ADDENDUM

JLG 24146.01-5 Dunn County Public Safety Center

Issued: November 13, 2025

ADDENDUM #: 03

6A LEVEL 1 FLOOR PLAN
SCALE: 1/8" = 1'-0"

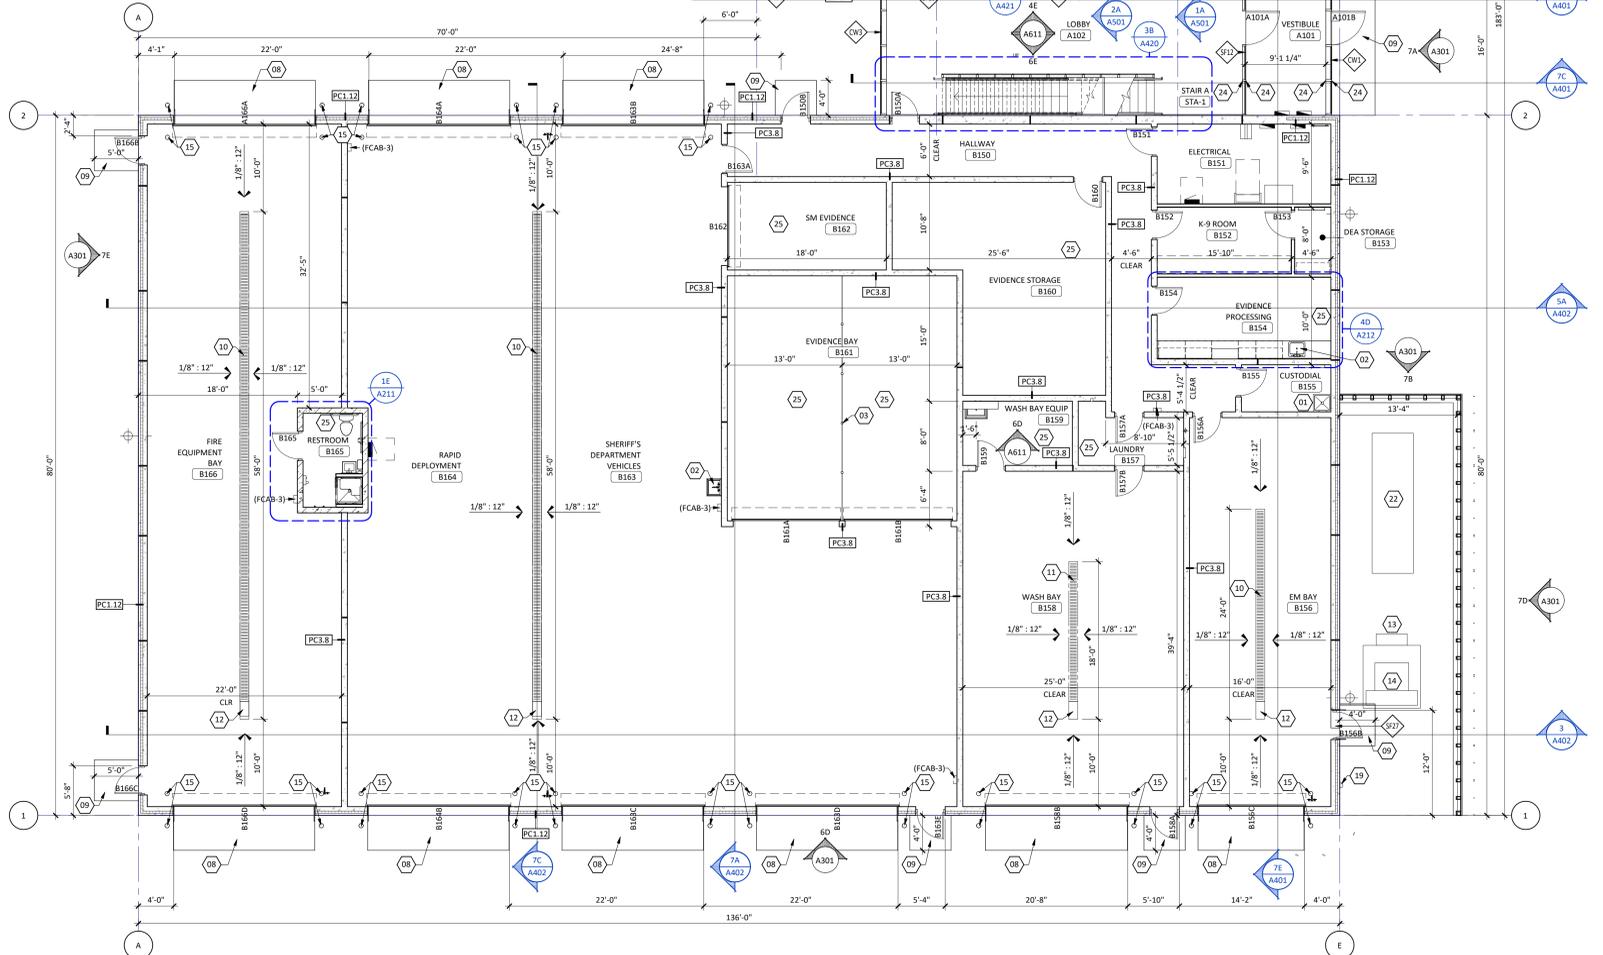
9. A201 – LEVEL 1 FLOOR PLAN
 - Replace sheet in its entirety.
 - Drawing 6A: Add 10' high by 3 ½" thick precast veneer along exterior wall as shown in Conference Room A103 and Break Room A122. Veneer to have PCFIN-30 for base bid finish and PCFN-20 for Alternate 4 finish.
 - Keynotes – Floor Plan: Add keynote "28" as follows: "10' HIGH BY 3 1/2" THICK PRECAST VENEER WITH (PCFIN-30) AS BASE BID AND (PC FIN-20) AS ALTERNATE 4."

5B BREAK ROOM A122 - EAST
SCALE: 1/4" = 1'-0"

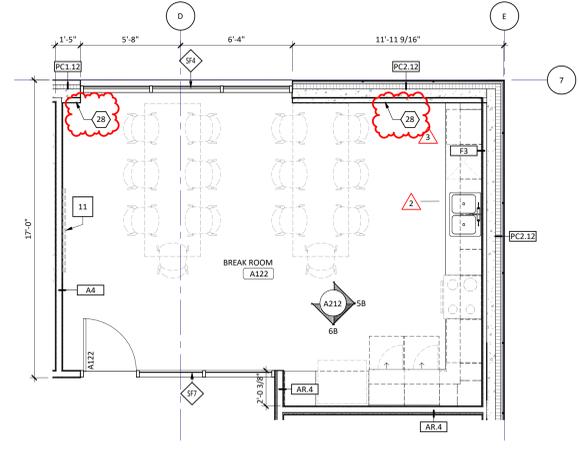
10. A212 – ENLARGED PLANS AND ELEVATIONS
 - Replace sheet in its entirety.
 - Drawing 5B: Revise cabinet widths as shown to accommodate precast veneer wall.
 - Drawing 4B: Add keynote 28 to precast veneer wall as shown.

7C STAIR A HOLLOWCORE EDGE
A422 SCALE: 1 1/2" = 1'-0"

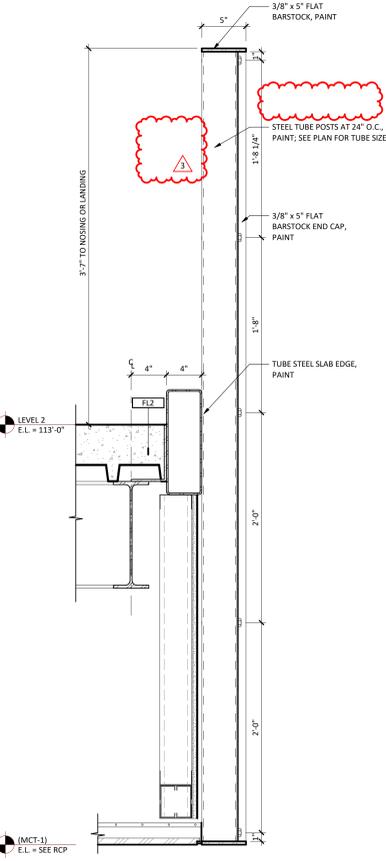
13. A422 – VERTICAL CIRCULATION DETAILS
 - Drawing 7B: Add notes for bent steel plate as shown.
 - Drawing 7C: Add detail in its entirety.
 - Drawing 6B: Remove handrail and related notes from detail at Bridge.
 - Drawing 2D: Add note " 1 ¼" I.D. stainless steel rail at Stair A locations only."

3A
A510 PIP - FOUNDATION S.O.G.
SCALE: 1 1/2" = 1'-0"

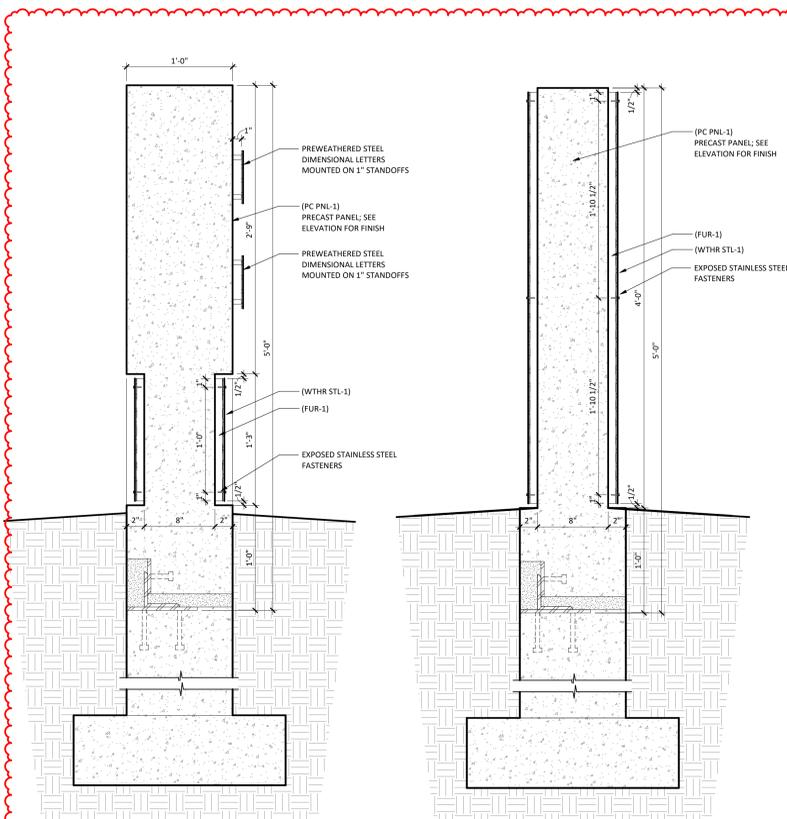
14. A510 – EXTERIOR DETAILS
 - Replace sheet in its entirety.
 - Revise Detail numbers as shown.
 - Drawing 1A & 2A: Add Monument Sign Sections in their entirety. Monument sign is Alternate 10.
 - Drawing 3A & 4A: Revise elevation name and height as shown.
 - Drawing 7D:
 - Revise title to read "Entry Canopy at Curtain Wall".
 - Revise detail to include dimensions and correct steel locations.
 - Add materials INSUL-36, WTHR STL-4, and FUR-1 as shown.
 - Drawing 6A: Revise drawing to remove drainage board DRAIN BD-1 from foundation wall and remove the vapor retarder and water proofing from underneath footing as shown.

7A A601 FINISH PLAN - BASEMENT
SCALE: 1/8" = 1'-0"

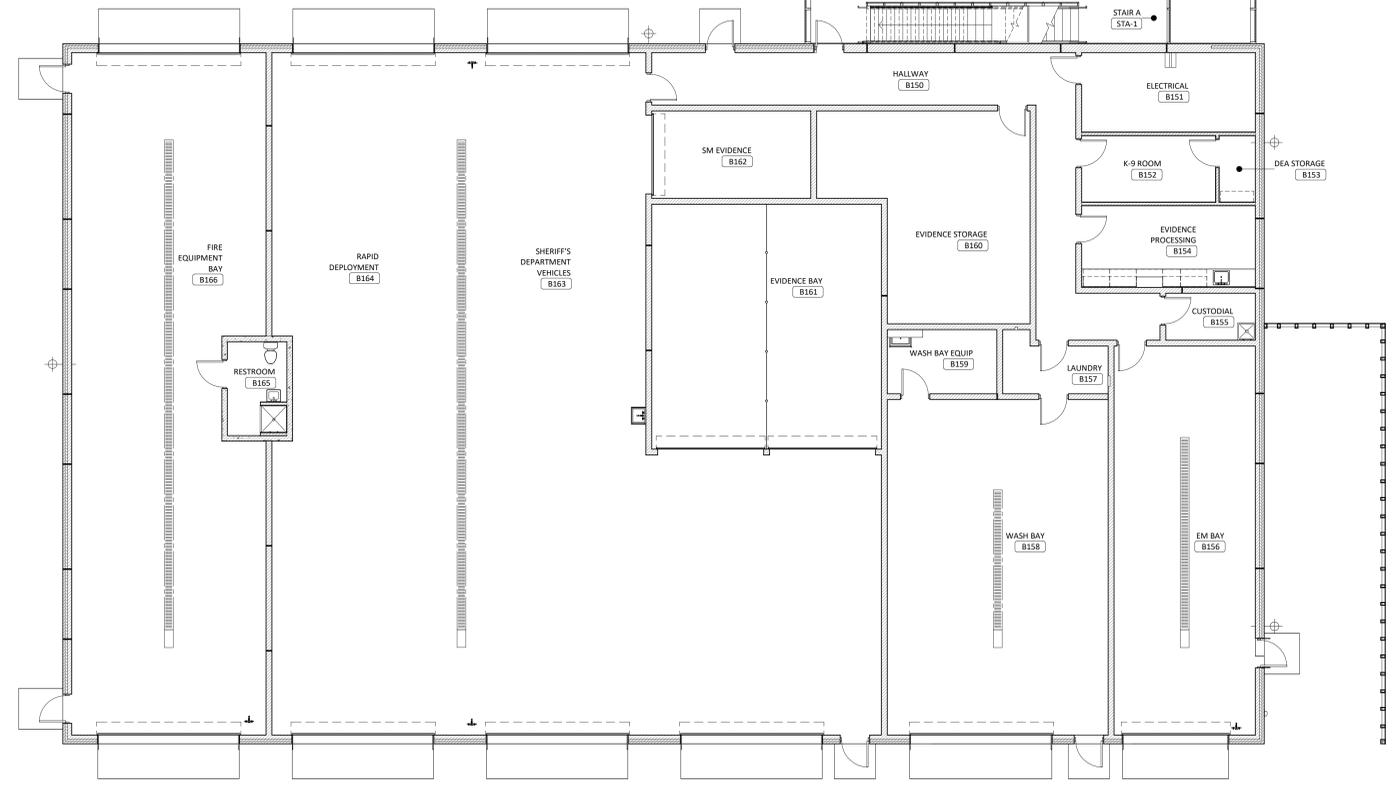
- Replace sheet in its entirety.
- Room Finish Schedule – Basement: Revise
 - A015 Mechanical and A015A Fire Pump wall finishes to “PT-1*” and remark “*PT-1 to be provided on gypsum walls only.”
 - Revise STB-0 and STB-1 wall finishes as shown.

6A FINISH PLAN - LEVEL 2
SCALE: 1/8" = 1'-0"

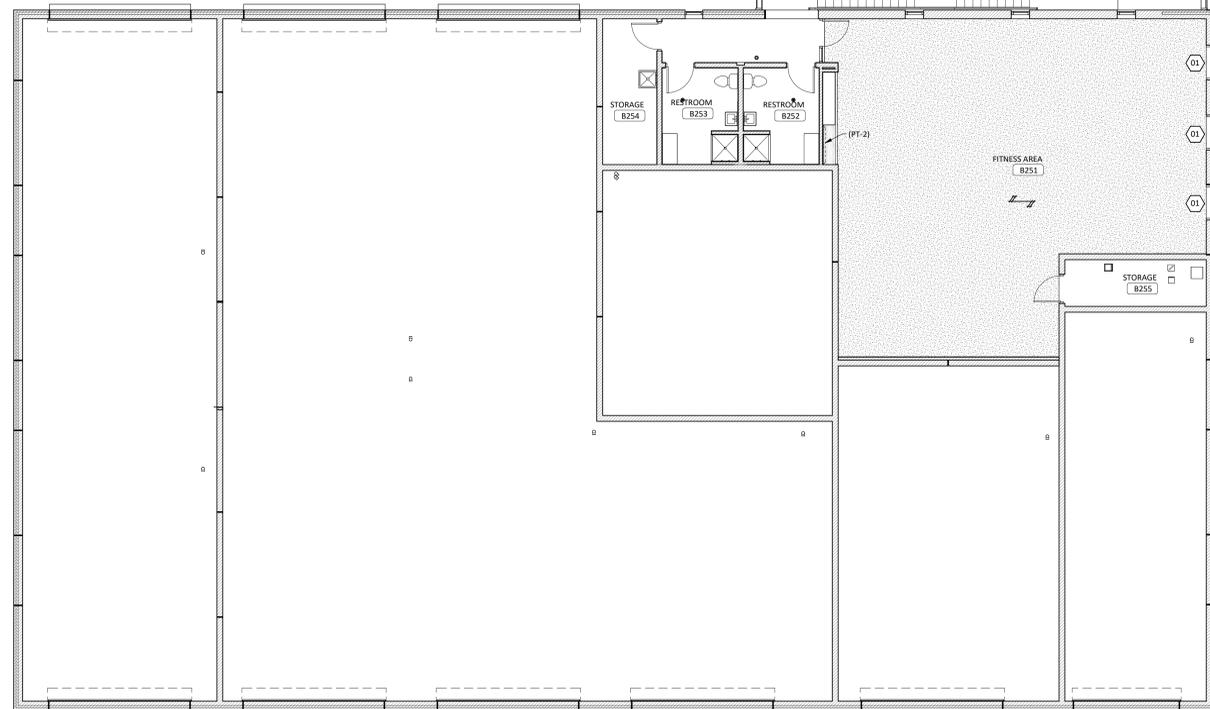
- Replace sheet in its entirety.
- Room Finish Schedule – Level 2:
 - Revise STA-2 and STB-2 wall finishes as shown.

6A
A701 BASEMENT FLOOR REFLECTED CEILING PLAN
SCALE: 1/8" = 1'-0"

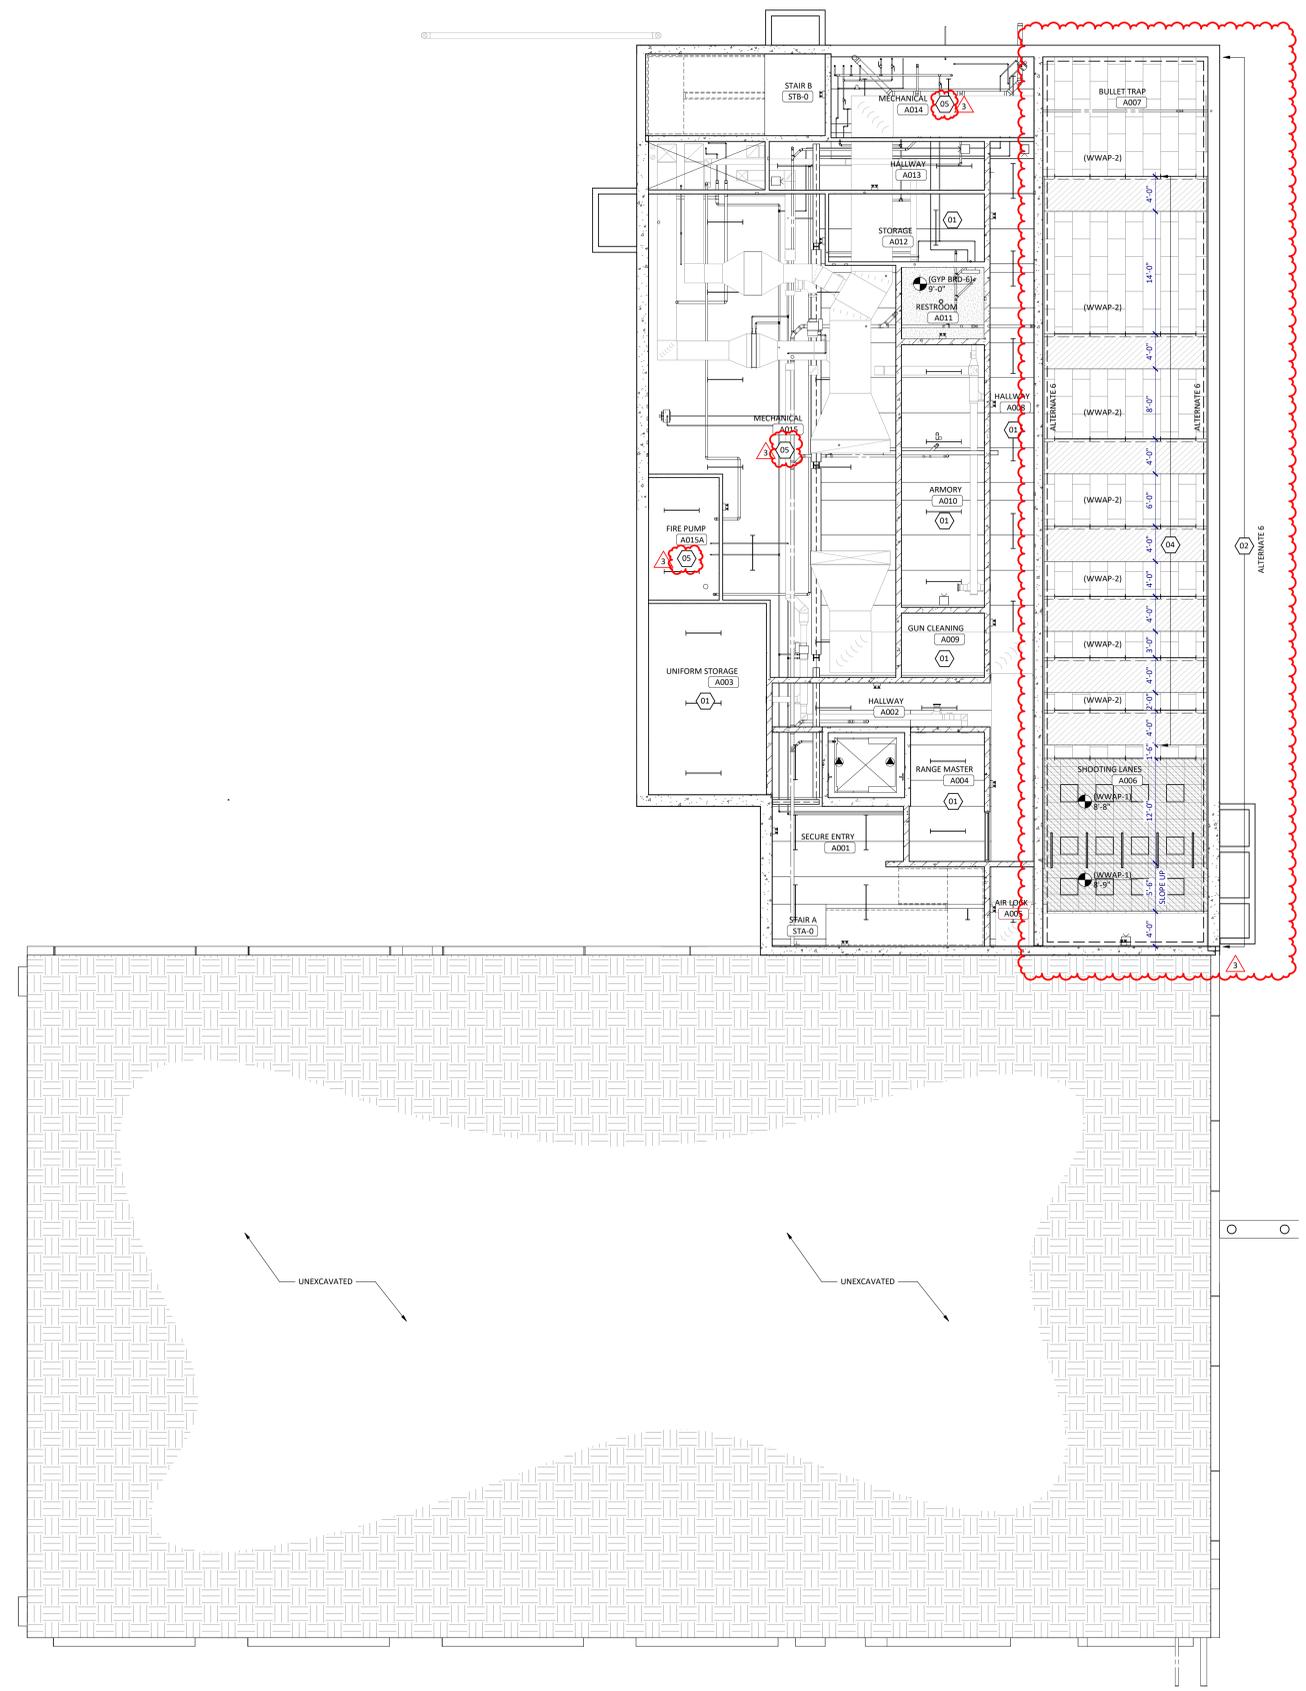
- Replace sheet in its entirety.
- Drawing 6A:
 - Adjust Shooting Lane A006 ceilings as shown.
 - Revise keynote in Rooms A014, A015, and A015A from “01” to “05”. No paint on exposed ceilings.
- Keynotes – Ceiling Plan –
 - Remove keynote “1 – Ceiling plan note”.
 - Revise keynote “03” to “04” used at Shooting Lanes A006.
 - Add keynote 5 to read “No paint at exposed ceiling.”

6A FIRST FLOOR REFLECTED CEILING PLAN
SCALE: 1/8" = 1'-0"

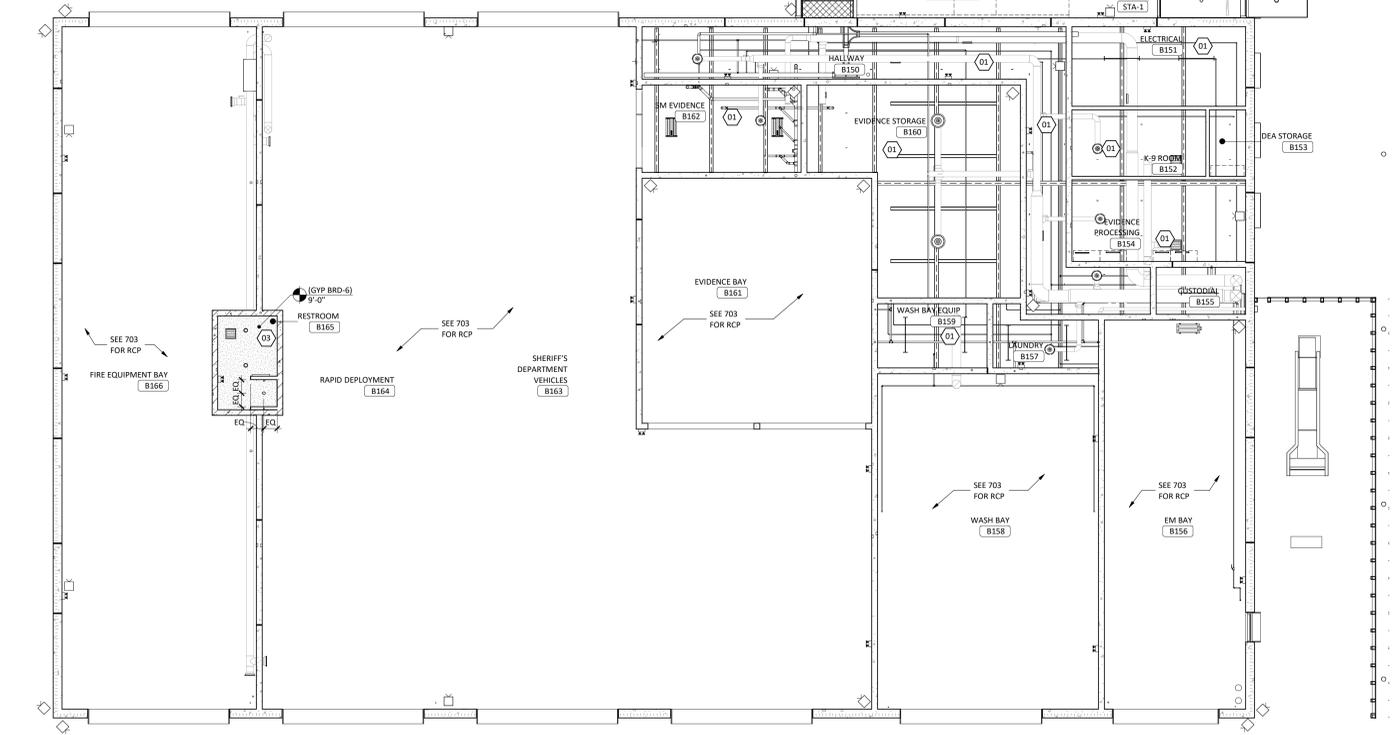
- Replace sheet in its entirety.
- Drawing 6A:
 - Revise ACT-2 hatch pattern as shown.
 - Remove window shade material id tags from reflected ceiling plans. Window shades are shown on finish plans with a keynote.
 - Add keynote 01 to exposed structure in Hallway A106.
 - Remove keynote 01 from Equipment Storage A118.

1 SIGN FOUNDATION PLAN
S101 1/4" = 1'-0"

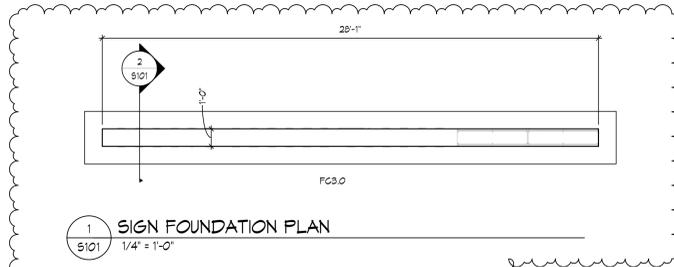
1. S101 – FOOTING & FOUNDATION PLAN
 - o Drawing 1/S101: Sign Foundation plan added.
 - o Detail 2/S101: Sign Foundation Detail added.
 - o Footing & Foundation Plan: Updated concrete pad footing elevations.
